09 - 2011  
BTD141, BTD141Z, BTD141H2  
18V IMPACT DRIVER KIT

## **SERVICE CHANGES**

### **1. Changes on Hammer Case Cover and Bumper**

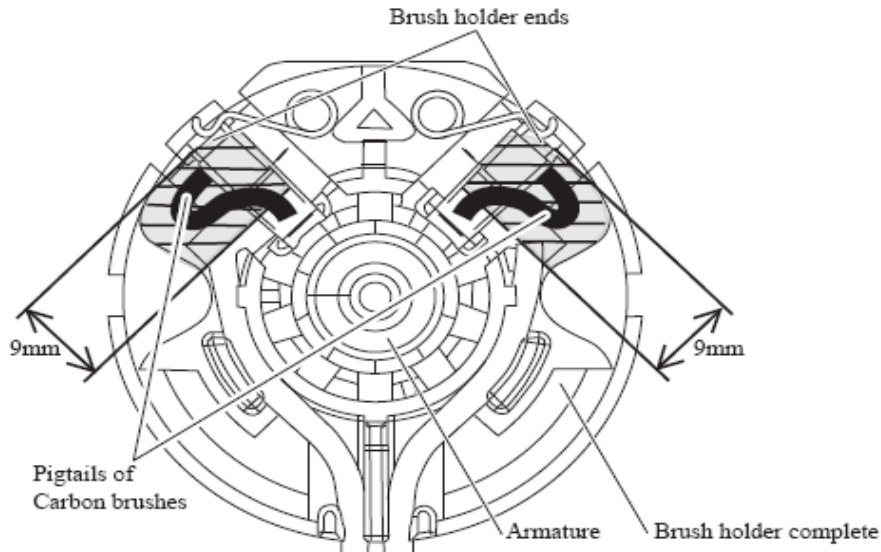
Item No.	Description	Type 1	Type 2
14	Bumper	424015-7	424369-2
15	Hammer Case Cover	450585-0	452409-6

Above parts are completely interchangeable as a set.

Type1: Bumper is hooked with the grooves of Hammer case.

Type2: Bumper is hooked with the protrusions of Hammer case cover as illustrated below.

### **2. Changes How to Assemble Carbon Brushes**

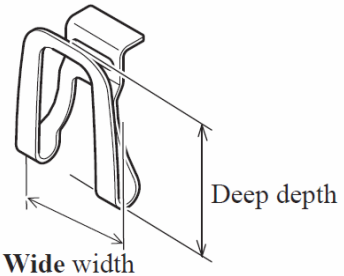
Item No.	Description	Type 1	Type 2
36	Carbon Brush	194427-5 (W/O ORIGIN)	195021-6 (W/ ORIGIN)

Do not protrude the pigtails of Carbon brushes from the specific spaces.

Refer to the following illustration.
